APPEAL SUMMARY

Appeal ID: 20805

Project Address: 929 SW Salmon St

Building/Business Name: Fountain Place Apartments

APPEAL ITEM 10
PROPOSED HORIZONTAL
ASSEMBLIES REFERENCE PLANS
FOR LOCATIONS

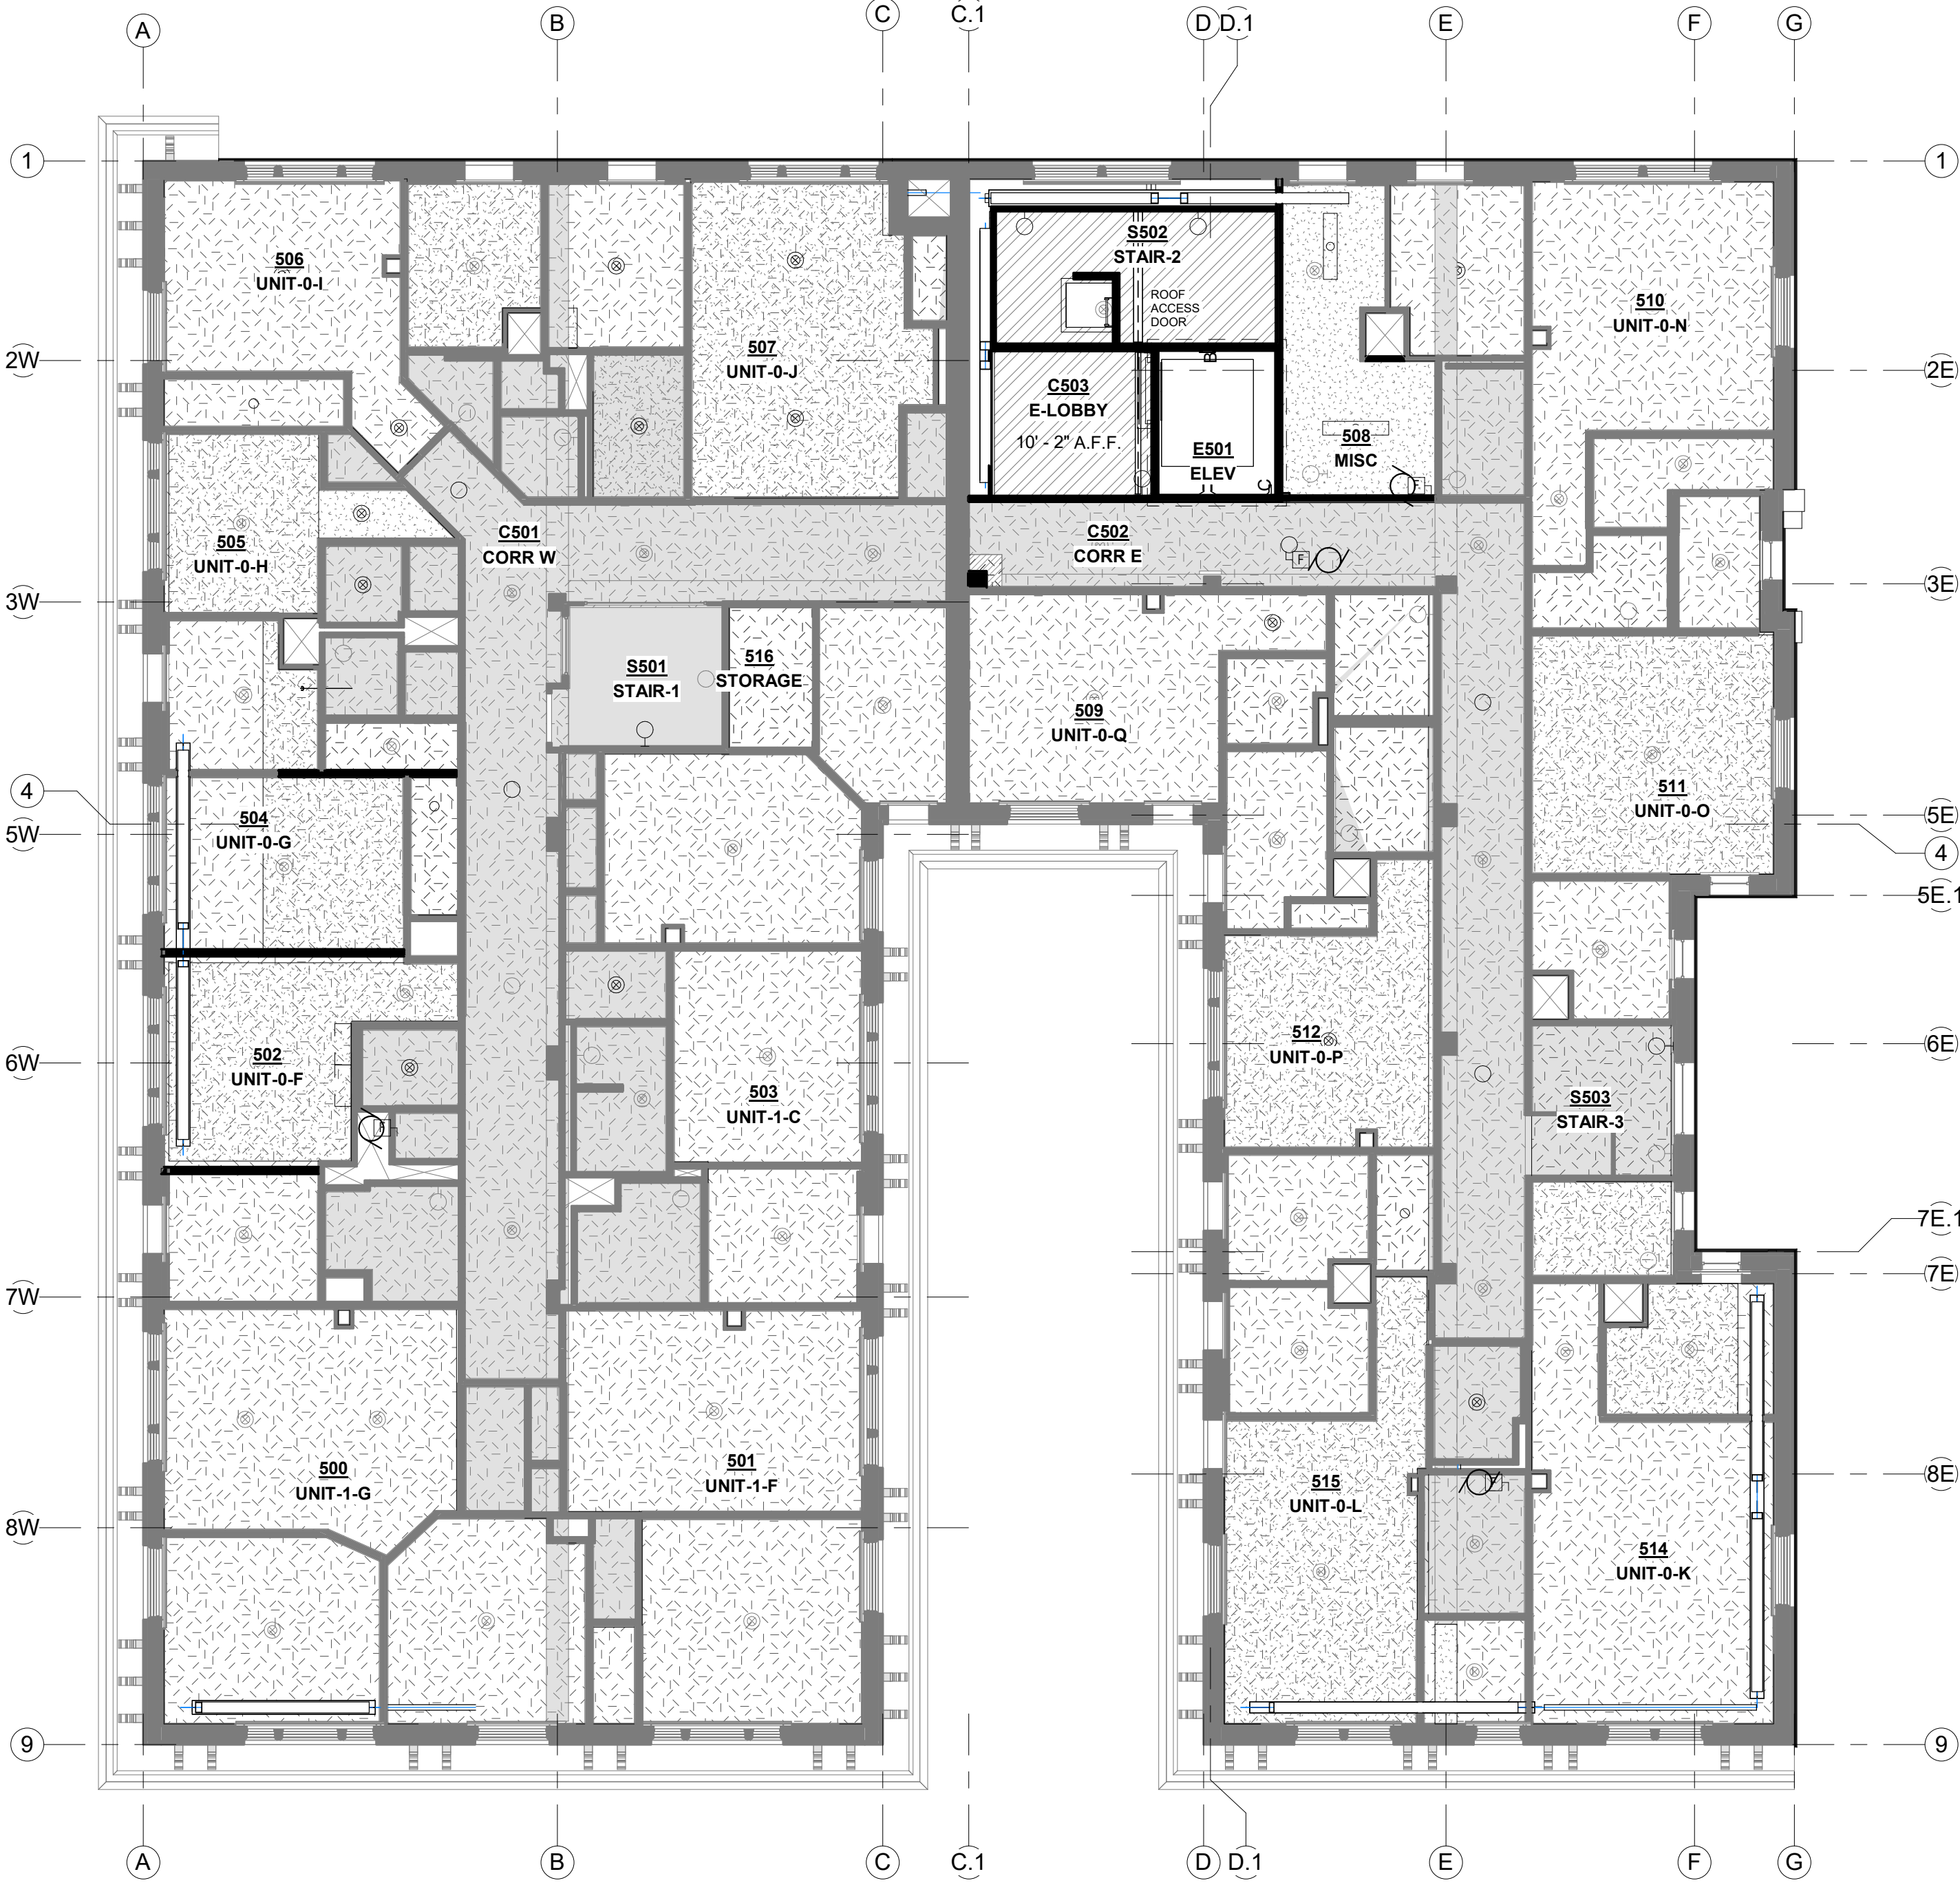
All horizontal assemblies require alteration due to the addition of a horizontal diaphragm and installation of perimeter brace frames as required as part of this voluntary seismic upgrade. The majority of the work will affect only the finish floor. The existing horizontal assembly consists of a 7/8" plaster and metal lath ceiling, 2x14 joists 16" o.c., 3/4" T&G subfloor, 1 1/4" air gap with sleepers, and 3/4" wood finish floor. The structural modifications will require the removal of existing finish floor and associated sleepers and addition of 2 layers of 3/4" plywood as a structural diaphragm. The existing 7/8" plaster and metal lath ceiling and 3/4" T&G subfloor will remain in-place. Units' finish floor will be LVT flooring with acoustical padding and corridors' finish floor will be carpet tiles.

This existing assembly with added diaphragm is calculated to have a fire resistive rating of 1 hour according to OSSC 722.6. The following is shown in the attached drawings: (2) 19/32-inch wood structural panel (30mins), wood floor 16 inches o.c. (10 mins), and Portland cement-sand plaster on metal lath 7/8" (25 mins) (722.2.1.4(2)). Other comparable 1 hour tested assembly are UL Des L501 and assembly 13-1.2 listed in Table 721.1(3).

This assembly will differ slightly in several locations where new perimeter brace frames are to be installed. In these locations, a portion of the horizontal assembly will need to demo-ed to allow for installation and then infilled around the new brace frames. Shoring around these areas will likely destroy part of the lath and plaster ceiling and the ceiling will need to be replaced. The only difference in these infilled areas from the above assembly is that the ceiling will be replaced with a layer of 5/8" gypsum veneer base board and minimum 1/8" veneer plaster which has an equivalent fire resistive rating of 30 minutes. Reference sheet G-551 for proposed assemblies and sheets A-150/A-151 for location of proposed assemblies.

The ceilings above and below the new community room will be replaced in order to meet code for fire resistive rating and sound ratings.

9. **Reconfiguration of trash room in Chapter 13 building: Granted as proposed.**
10. **Alteration of horizontal assemblies: Granted provided rooms with areas of patch and repair exceeding 15 percent of the room area have full ceiling finishes removed with replacement as 1 hour rated assembly as approved as part of City building plan review.**

APPEAL ITEM 2
DOOR 009-2, TRASH ROOM
ACCESS

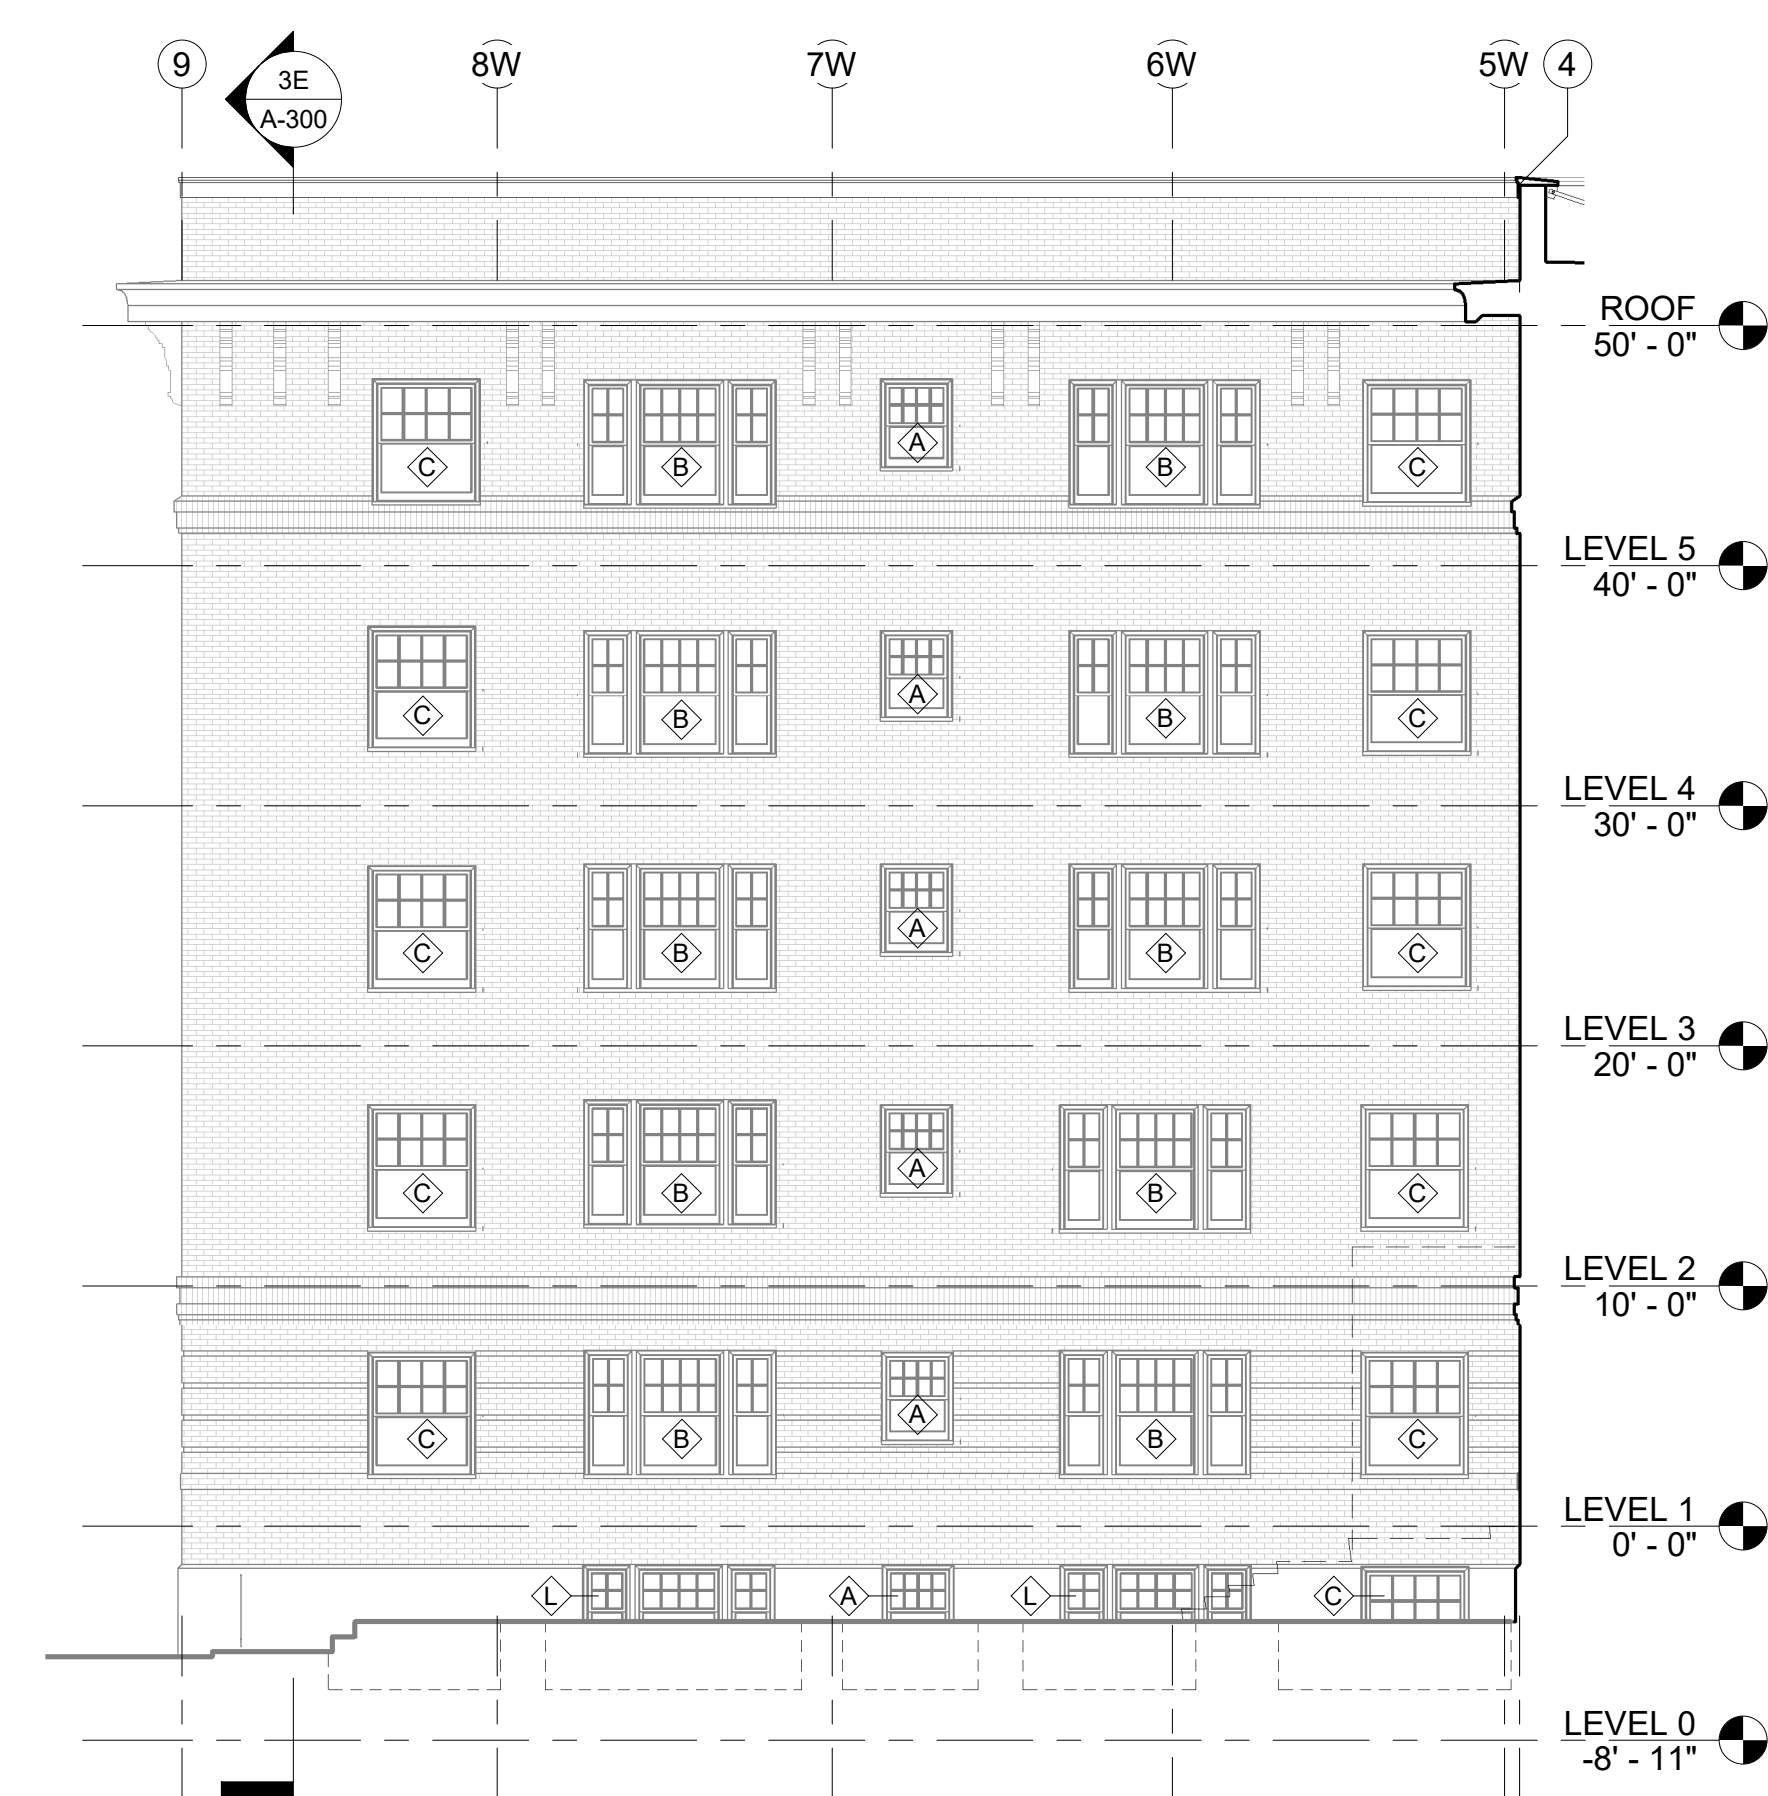
Proposed Design Three exterior doors are proposed along the north elevation of the building; 2 replacement doors and 1 new opening. The doors provide access to the following:

C001-1: Accessible Building Entry (Door set flush to exterior, automatic door opener to be provided)

S002-2: Accessible Building Exit (Door to be set flush with interior to provide accessible exit)

009-2: New Opening - Trash Room Access (Primarily accessed by maintenance personnel)

Reason for alternative The exterior walls are over 1'-6" thick. The existing wall thickness does not allow installation means to meet the requirement for recessed doors (404.2.3.5). Each door will be installed such that it is recessed for only a single direction of travel.

It is expected that Door C001-1 will provide the primary accessible entry to the building. Door will be set flush with exterior to maintain accessible clearances for building entry. Door C001-1 is

located in an existing opening. An existing wall to remain impedes the required maneuvering clearances (404.2.3) on the interior side of the opening. An automatic door opener will be provided at this opening.

Door S002-2 provides an exit from the proposed egress stair to the exterior. Door S002-2 will be set flush with the face of the existing interior wall to maintain required clearances for occupants exiting the building. The new concrete shear wall will be held back around the opening to maintain maneuvering clearances. From the exterior neither the recessed door requirements nor the minimum maneuvering clearances are maintained at this door. The walkway serving the door is located between the building and the adjacent building/lot line, limiting the maneuvering clearance perpendicular to the doorway, 48-inches rather than 54-inches is provided. Door will be used primarily for exiting, accessible entry will be provided at door C001-1.

Door 009-2 provides access from the trash room to the exterior of the building. Door will be primarily used by maintenance personnel to transport trash for collection. Accessible access to the trash room will be provided from the building interior.

1. **Use of recirculating range hoods in residential units: Granted as proposed.**
2. **Maneuvering clearance at existing doors: Granted as proposed.**
3. **Alterations level 0 - 5 in Chapter 13 building: Granted as proposed with actual occupant load to be verified at time of plan review.**
